Basecamp Phase 2 Apartments – Drainage Letter

Drainage Letter

Basecamp Phase 2 Apartments, Steamboat Springs, Colorado

Figure 1- Vicinity Map

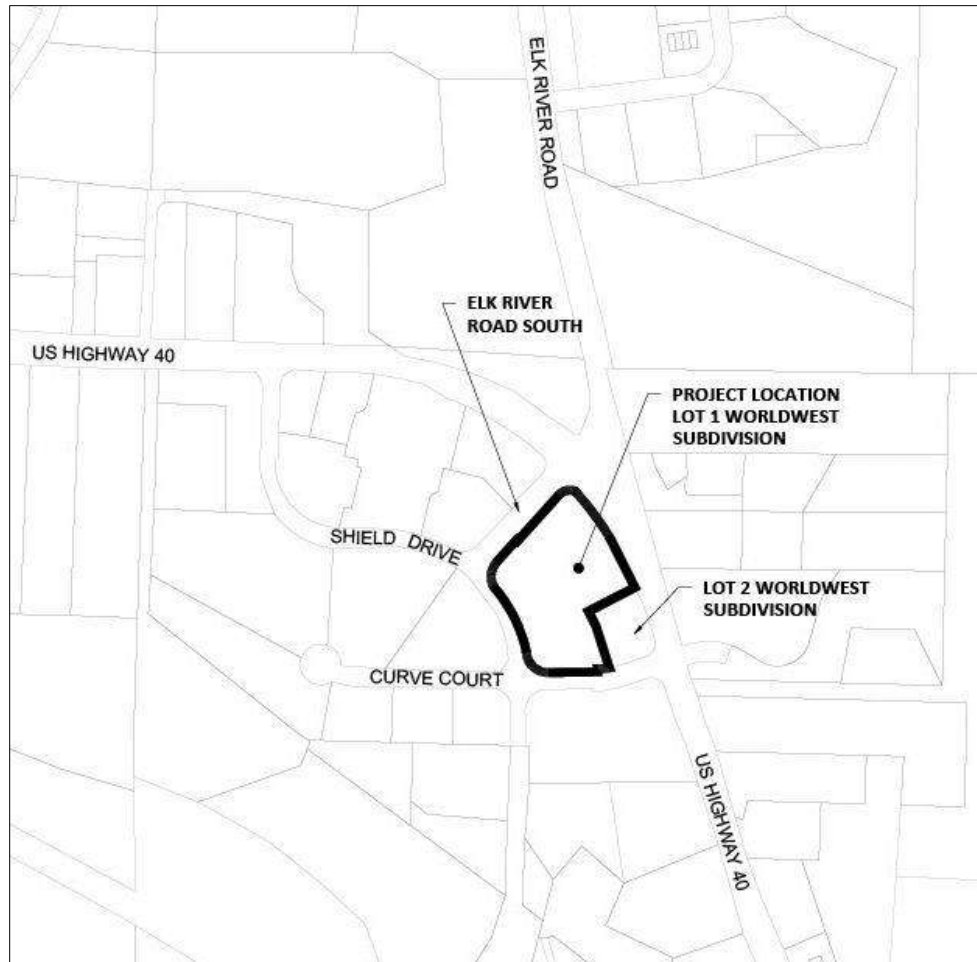
(Drainage Letter): Please show all calculations for all subbasins.
